## **SURVEY STREET, LENNOX HEAD – WATER MANAGEMENT**

This letter addresses the water management issues raised in the Department of Planning (*DoP*) letter dated 4 December 2006 and the related submissions with respect to the Environmental Assessment for the above residential subdivision.

FIGURE 1

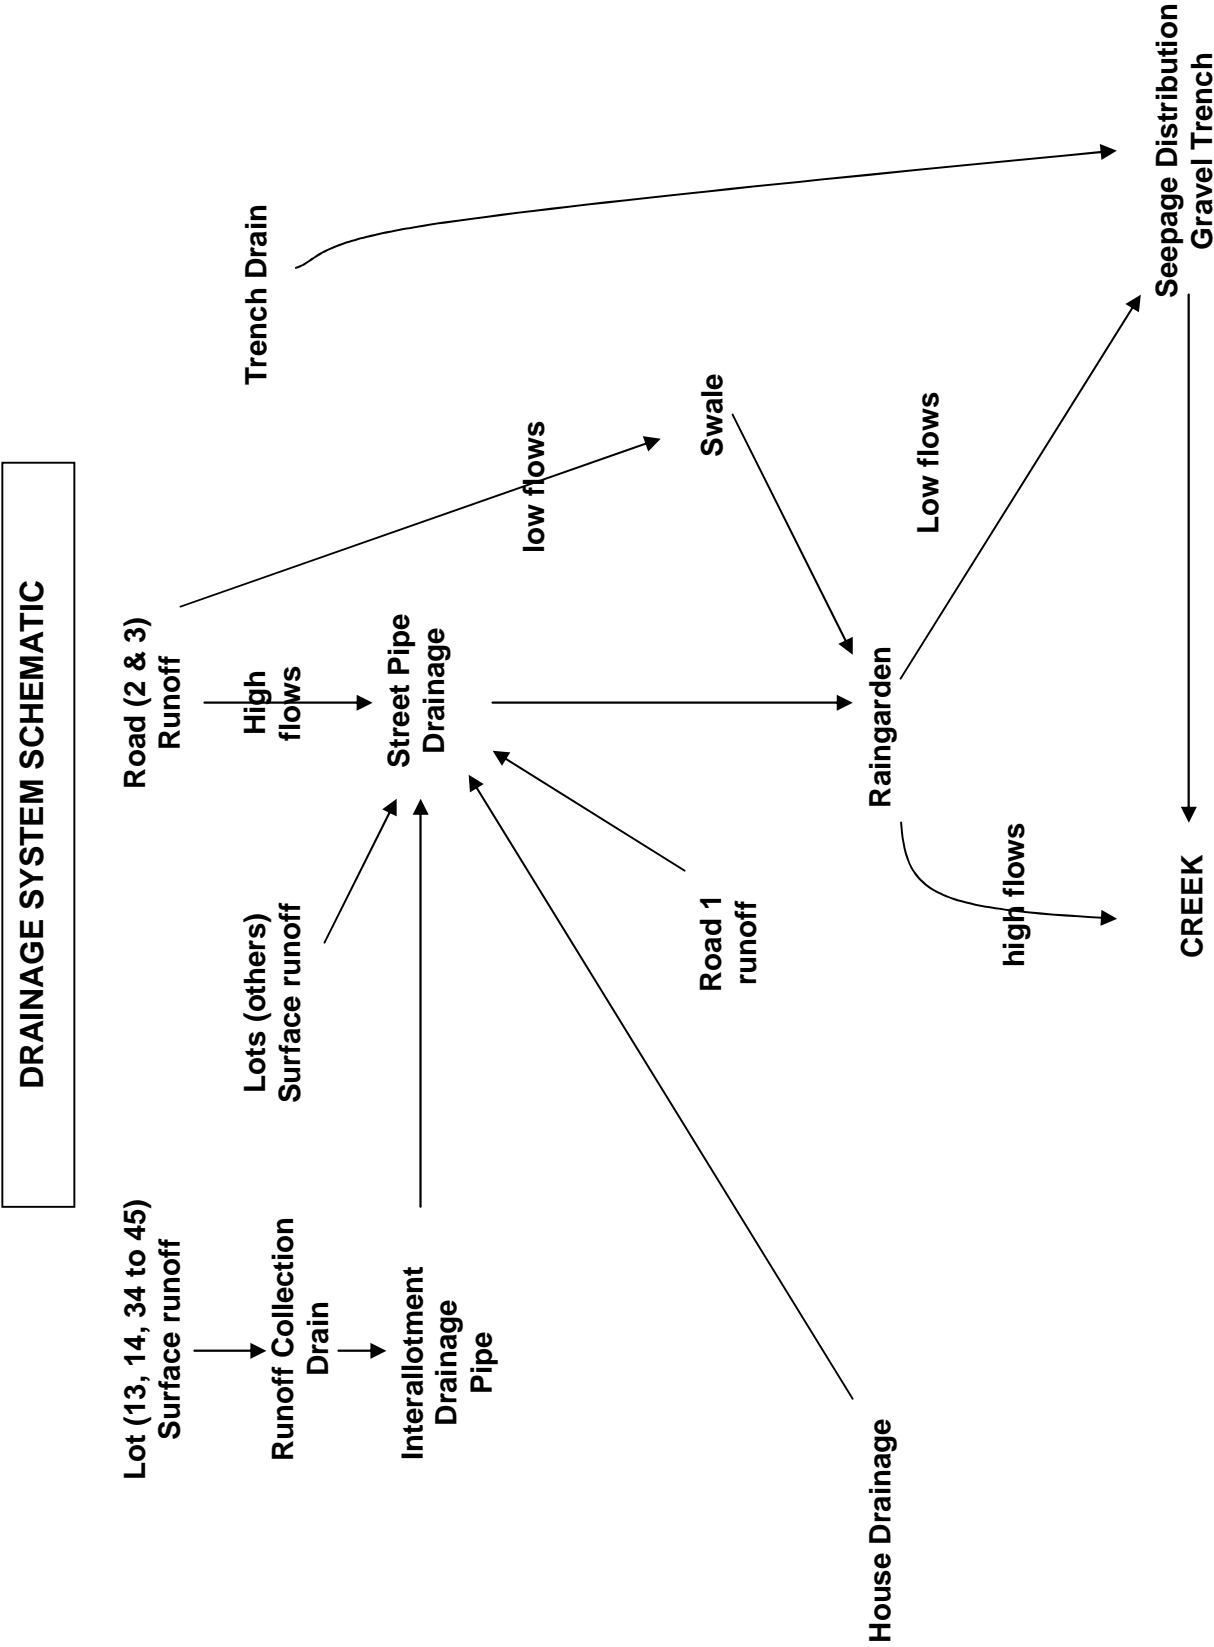
6. All drainage connections have been clarified in the attached **Figures 1 to 3**. The low flow from the raingardens would be discharged to the seepage distribution trench gravel drain. This would permit a slow and evenly distributed overflow and seepage to the creek which would not cause scour.

FIGURE 2

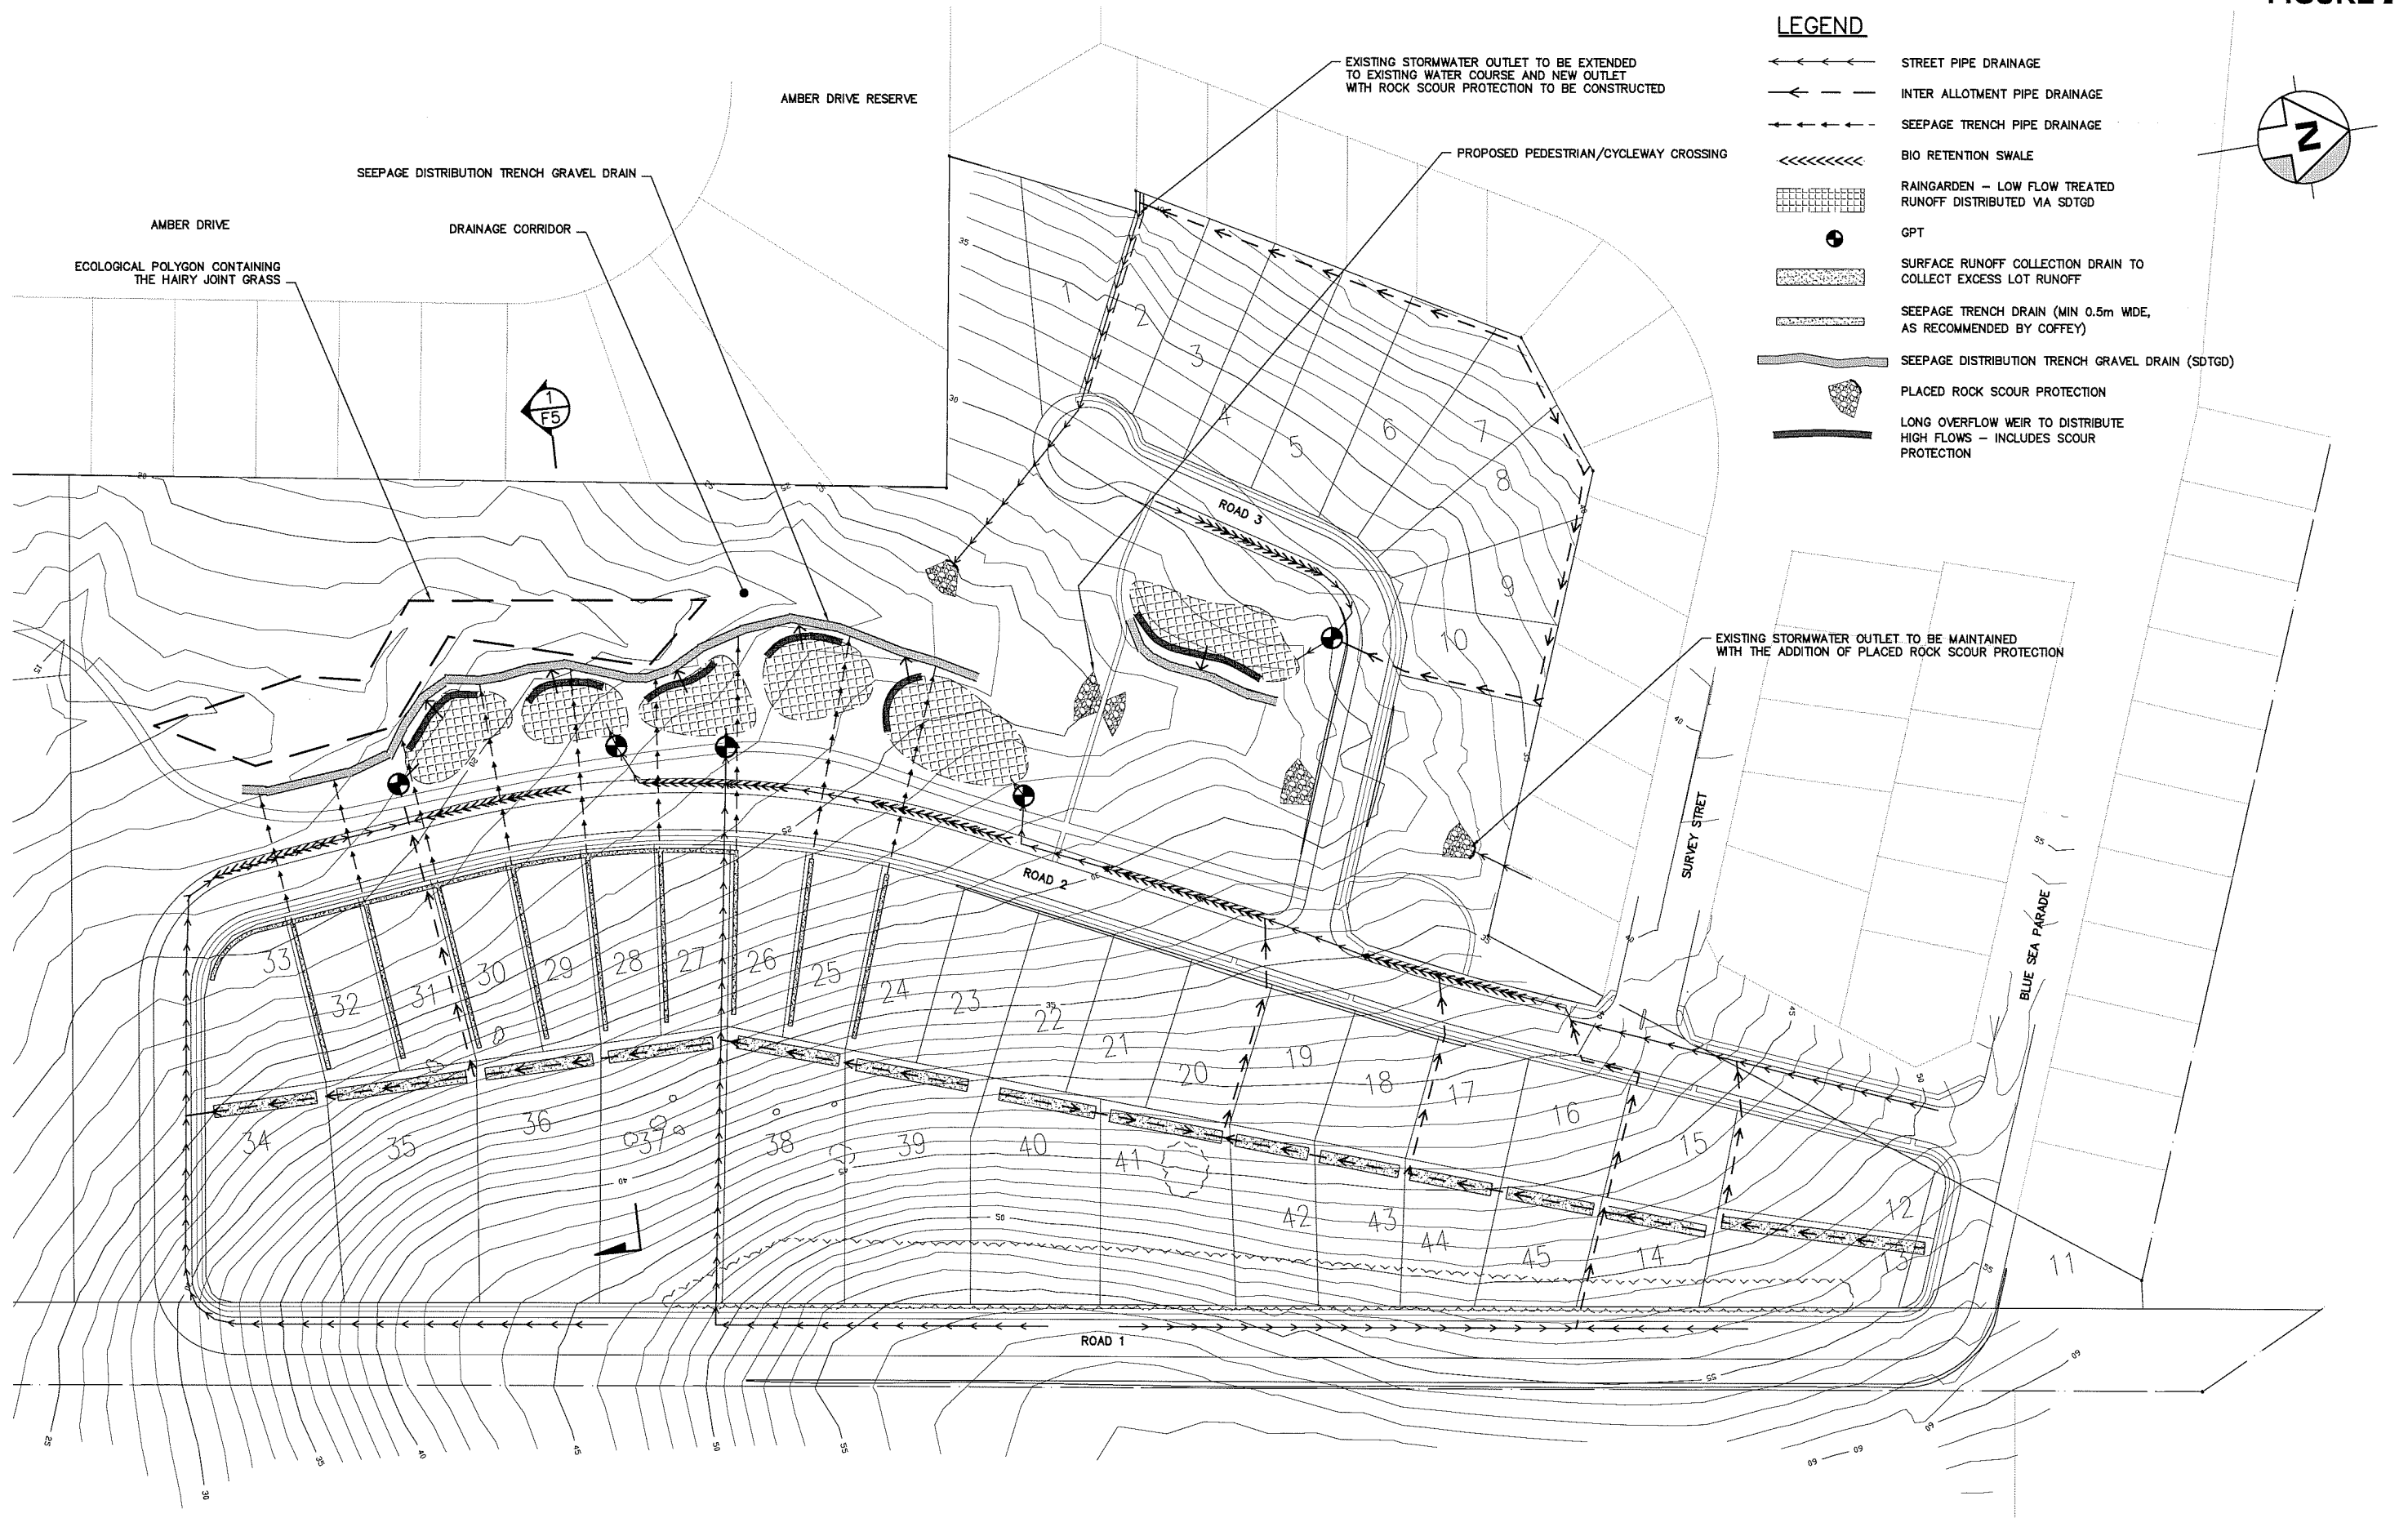
- the seepage will be collected in trench drains and will be separate and independent of the street drainage system. The drainage pipes from these trenches will direct seepage to the seepage distribution trench gravel drain (refer **Figure 2**). This trench will permit gradual and distributed overflow and seepage of this water along the creekline to replicate the boggy nature experienced in the existing conditions. In this way, the boggy nature of this area adjacent the creekline will be maintained. This is the dominate hydrological process

7. The high flow discharge from the raingardens has been clarified in **Figure 2**. Each pond would be independent with flow over a long discharge weir to distribute the flow over a wide area and provide scour protection.

FIGURE 3

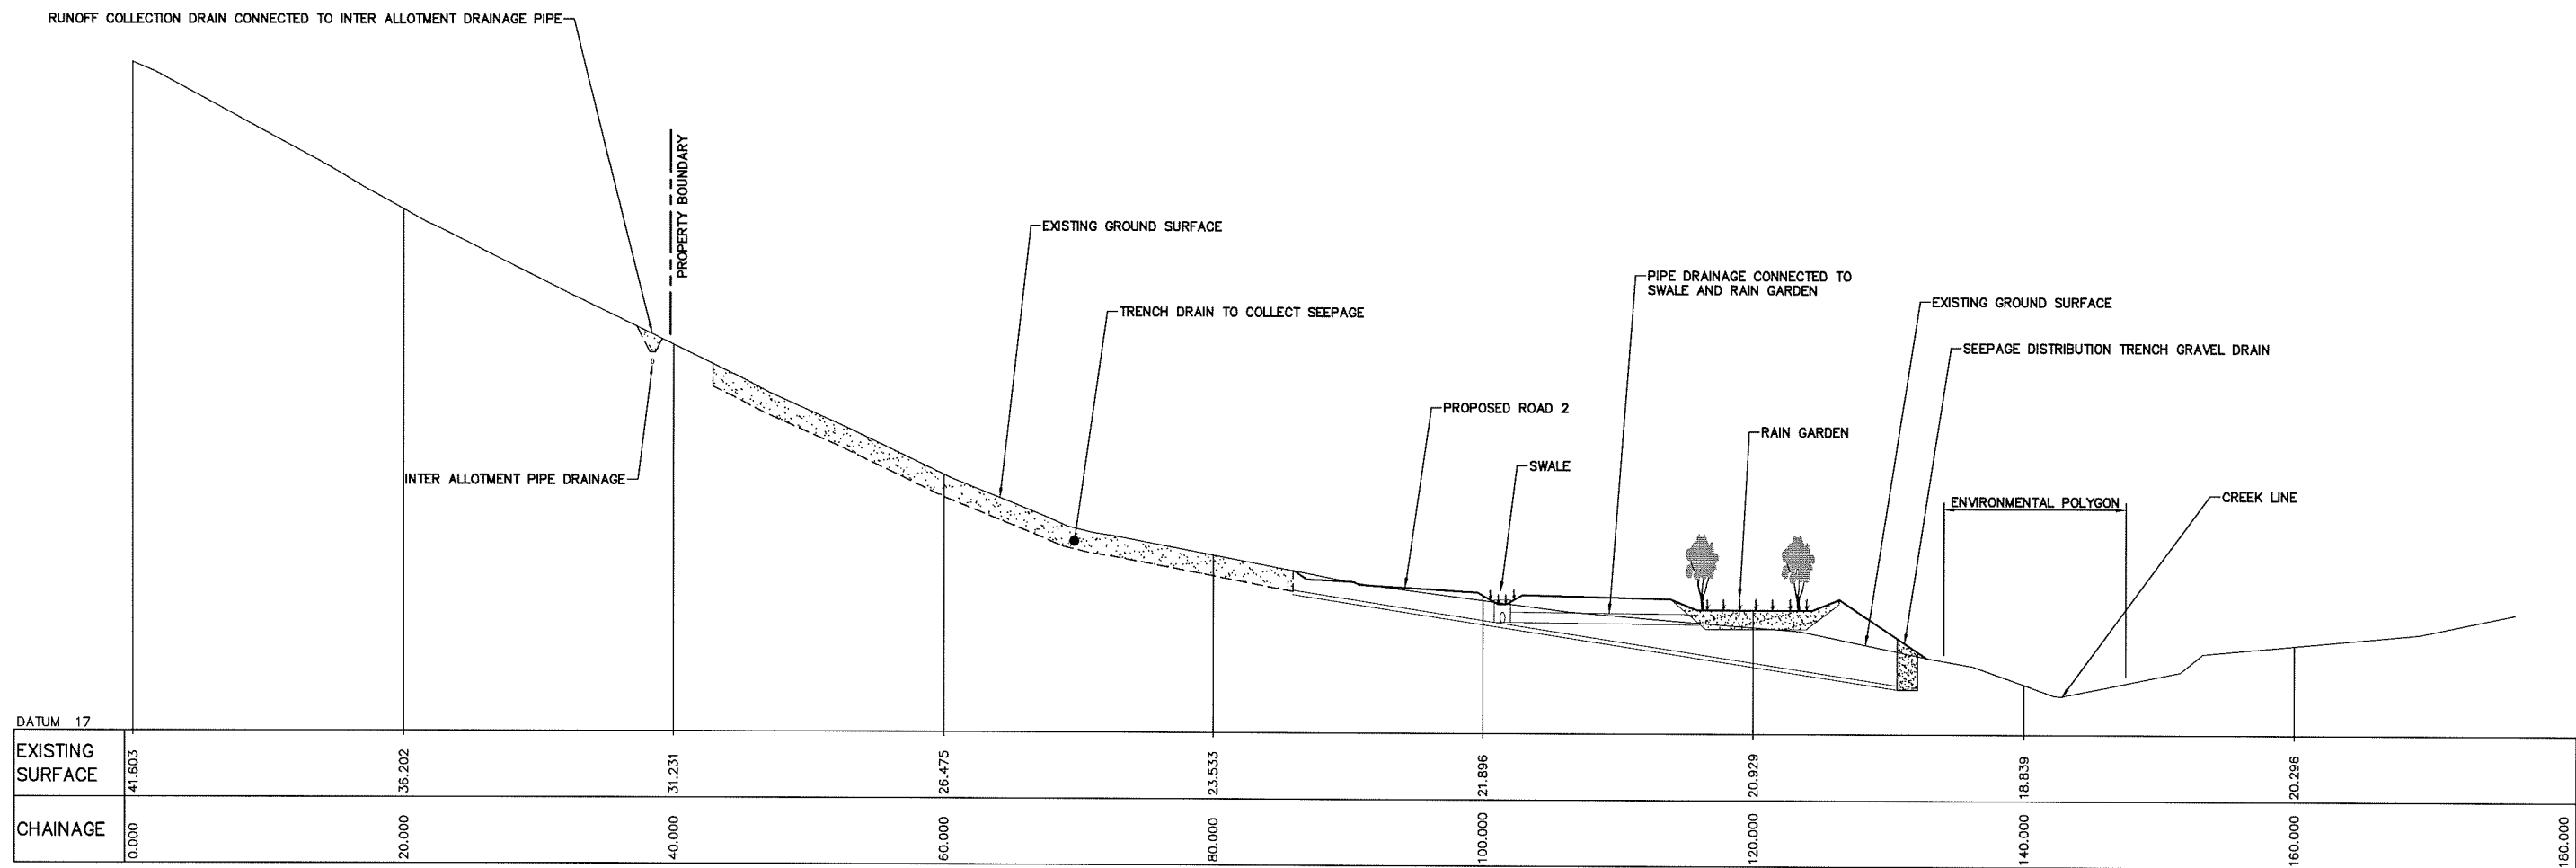
The majority of issues revolve around the proposed strategy for management of stormwater and natural seepage water. A number of misunderstandings need to be clarified at the outset as these will address the majority of issues. Three drawings are attached to assist clarify the proposed stormwater system. A schematic is provided in **Figure 1** to clarify the connections between elements and between different systems. The various stormwater elements are presented in plan view in **Figure 2** to show the physical layout and connections between these elements. The cross section of the stormwater system clarifies the vertical relationship of various elements (refer **Figure 3**).
